LIPPERT
COMPONENTS®

Product Change Notice – 3000 Series C-Hinge Notch Removal

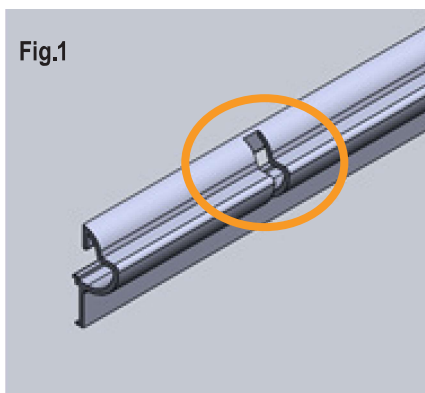
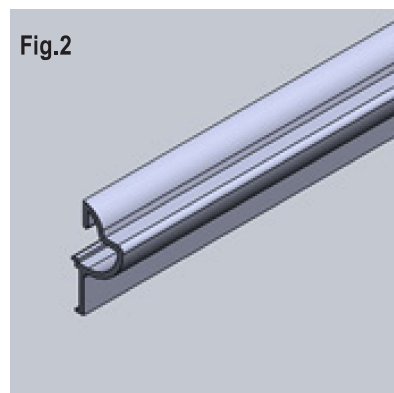
As part of our ongoing efforts to improve product performance, we will be removing a process notch and set screw in the C-Hinge of 3000 Series windows.

The function of the notch and set screw was to reduce lateral movement of the vent. The new design includes lengthening the hinge by 1/8" for improved stability of the vent. Removing the notch will also standardize production processes across the windows division.

This applies to all 3000 series windows using the c-hinge in the area circled in (Fig.1). A set screw will still be applied to double vented windows between the two vents. The change does not affect operation of the window. There is also no change in installation for the OEM customer.
